Amendments to the Drawings

FIG - 1

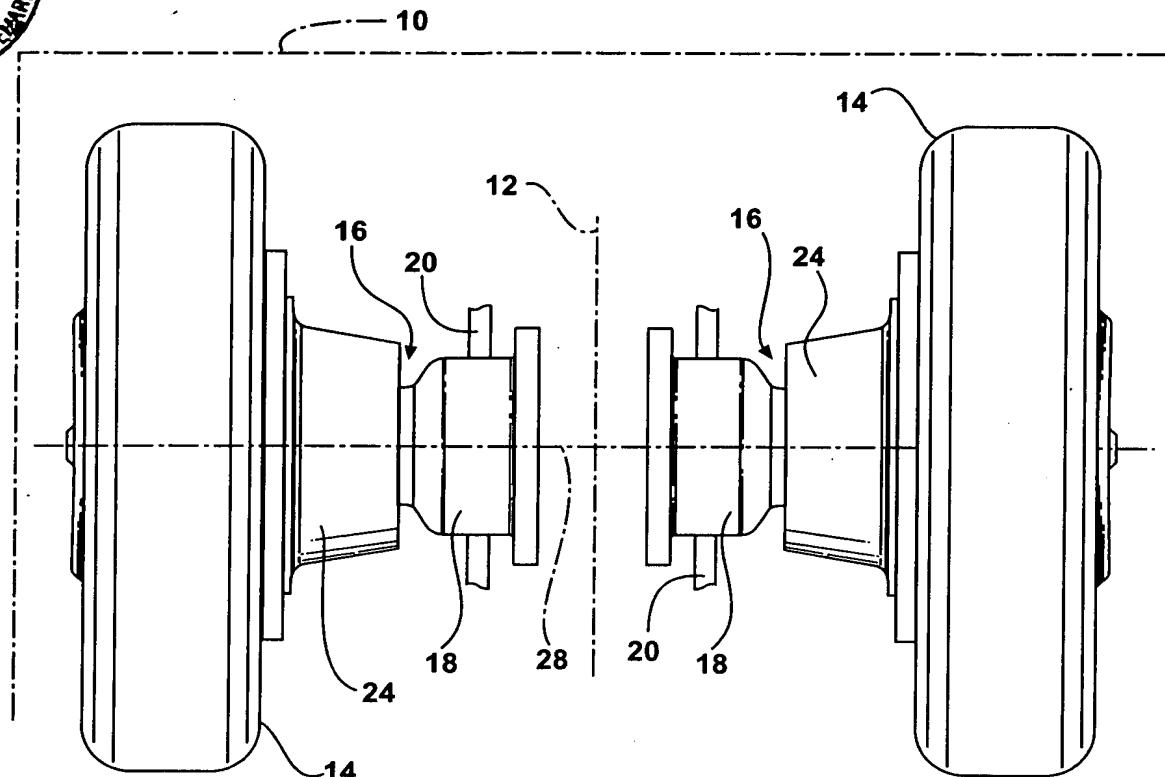
The attached sheet of drawings includes changes to Figures 1 and 2. In particular, Figure 1 has been corrected to properly orient the driven wheels 14 on the wheel hubs 24. Applicant inadvertently positioned the wheels 14 adjacent the non-rotating spindle 18 at the time of filing. As is clear from the specification, the wheels 14 are to be mounted on the wheel hubs 24, as is now illustrated. Figure 1 has also been amended to include reference numerals for the non-rotating spindles 18, the vehicle structures 20, the wheel hubs 24, and the axis of rotation 28. Figure 2 has been amended to include a reference numeral for the hubcap 70 and correct the position of the leader line for the central bore 54. No new matter is being introduced by way of these amendments/corrections. This sheet, which includes Figures 1 and 2, replaces the original sheet including Figures 1 and 2.
